## CRITIC'S CORNER MORGAN 30

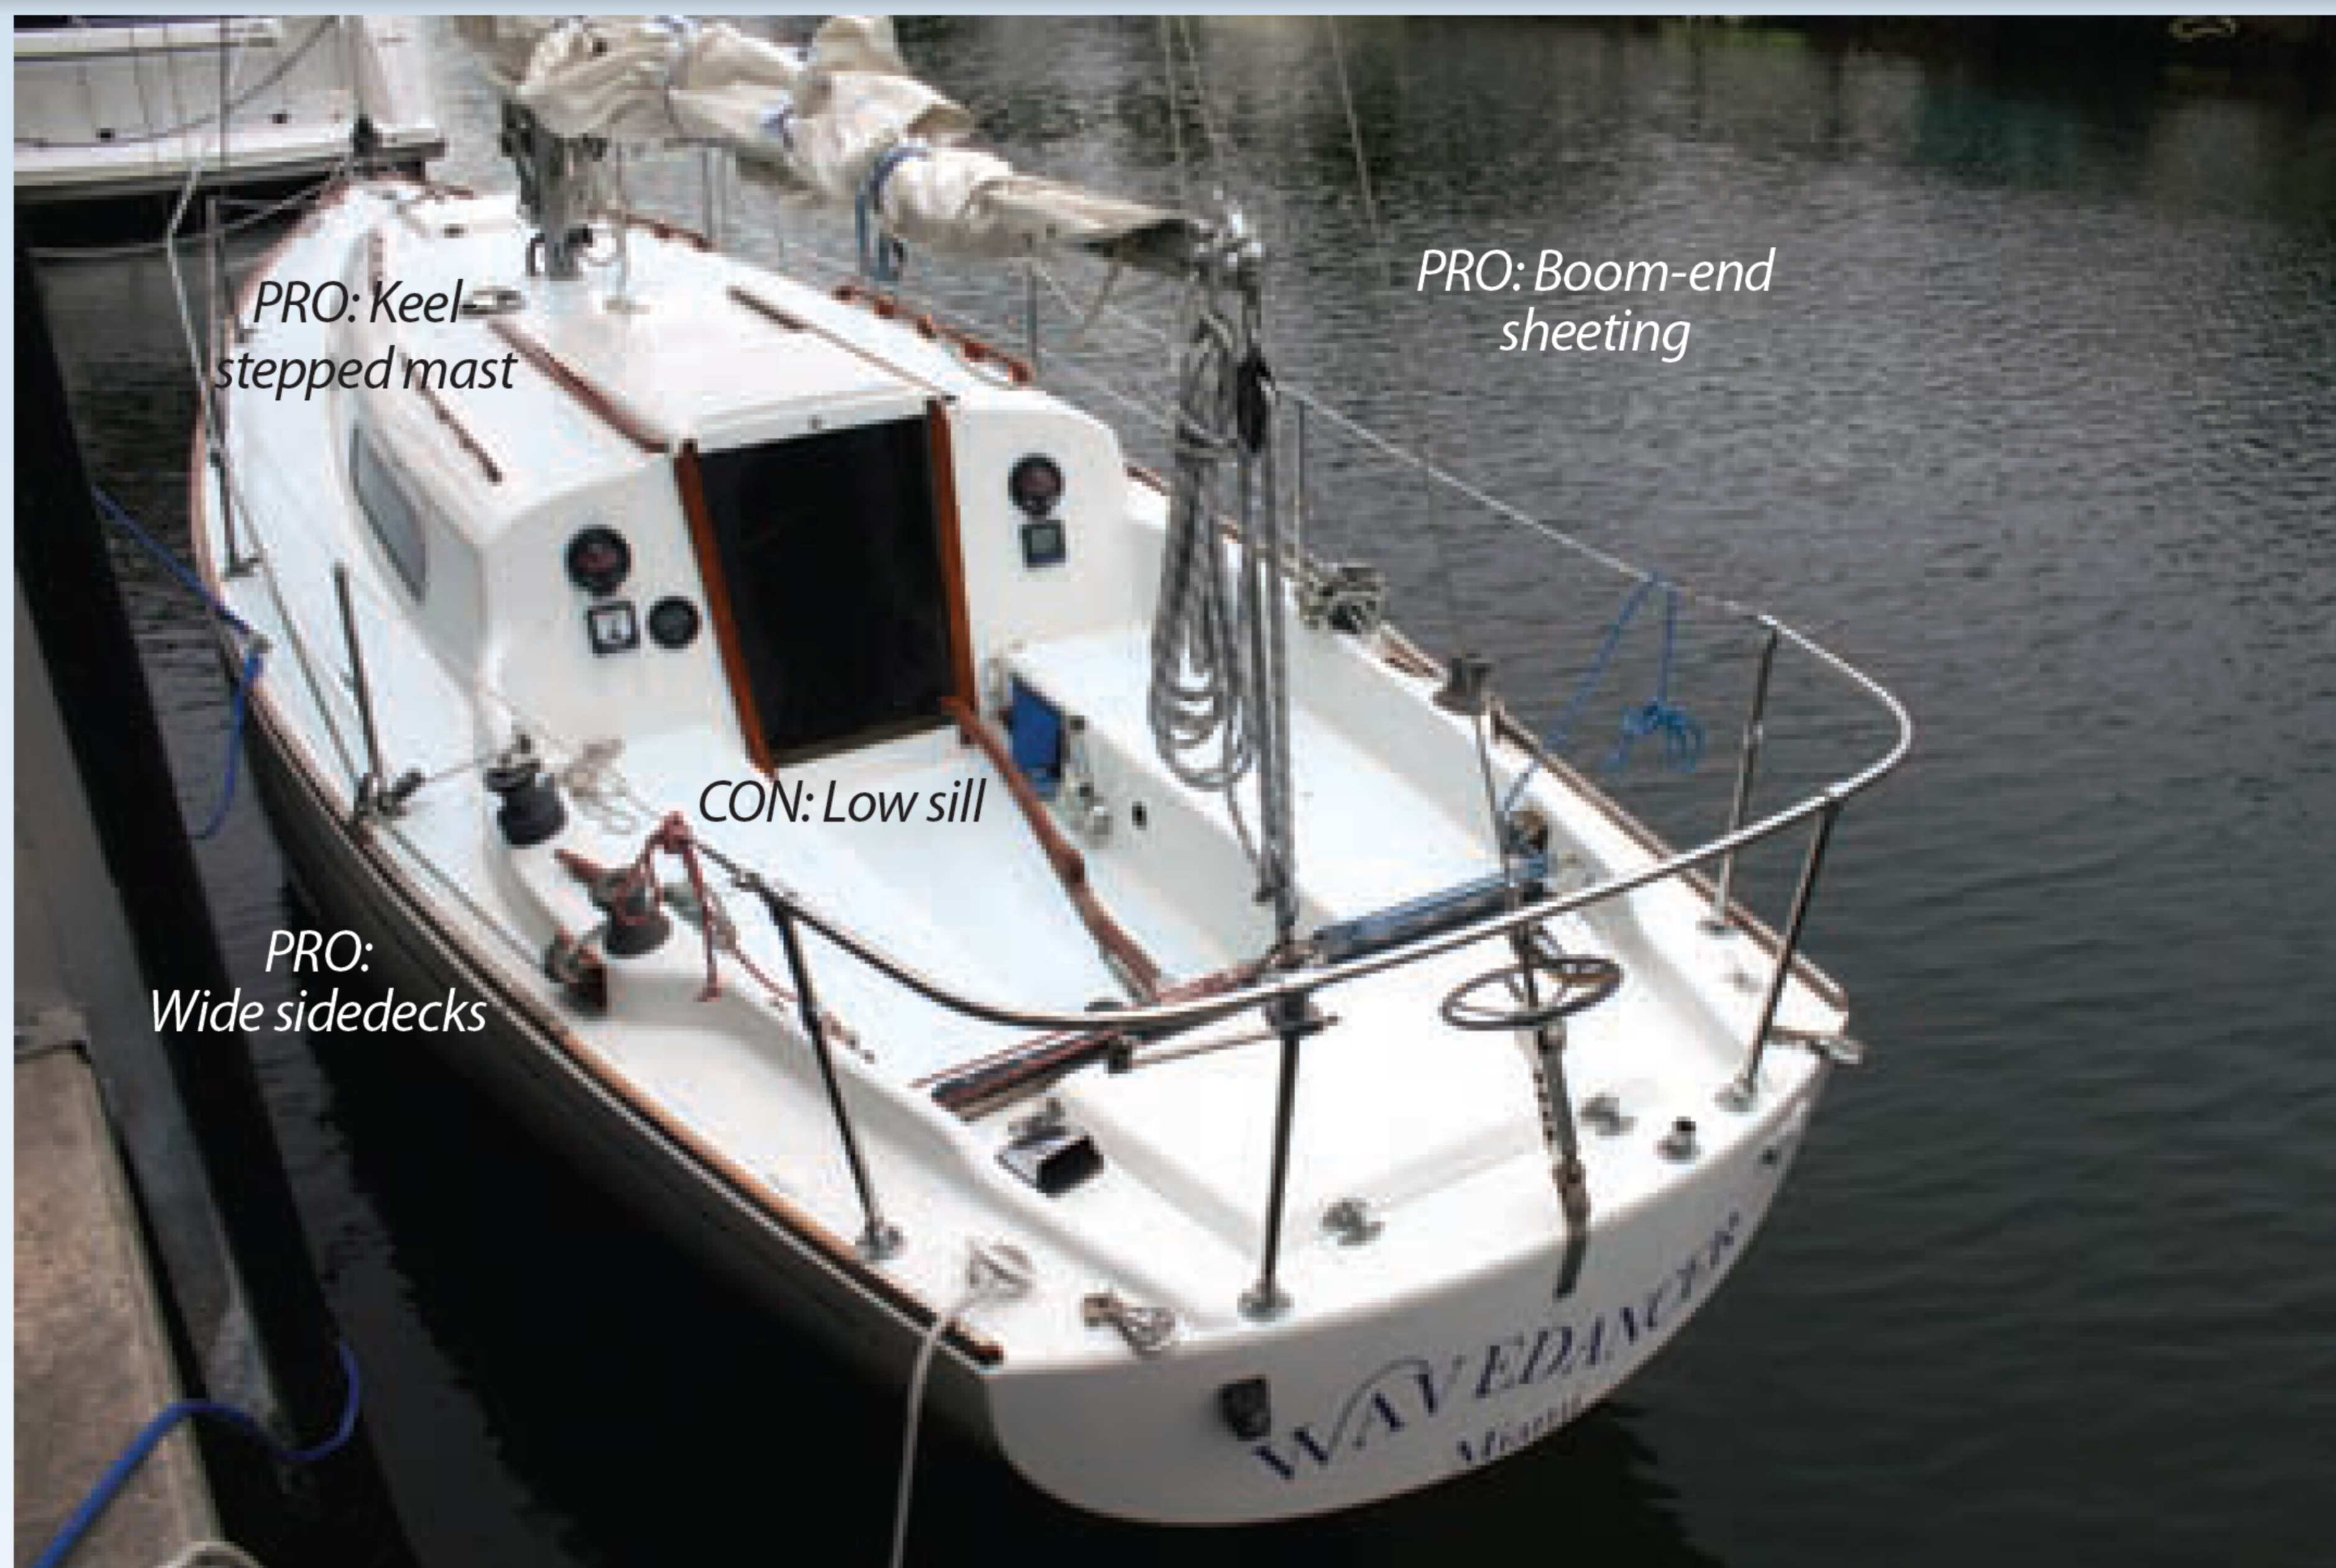
- Wide sidedecks allow easy passage fore and aft.
- Clear view from the helm.
- End-boom mainsheet keeps load where it belongs.
- Keel-stepped mast reinforces rig.
- Double lifelines (optional) add security.

- Low sill exposes companionway to downflooding.
- Big masthead genoa not well-suited for quick tacks.
- Roller-furling boom more trouble than it is worth.
- Molded foredeck hatch not as water-tight as a gasketed aluminum-frame, acrylic or Lexan hatch.

*Most of the shortcomings of the Morgan 30 are typical of boats of its era and can be remedied by retrofitting with new hardware and some modifications. .*
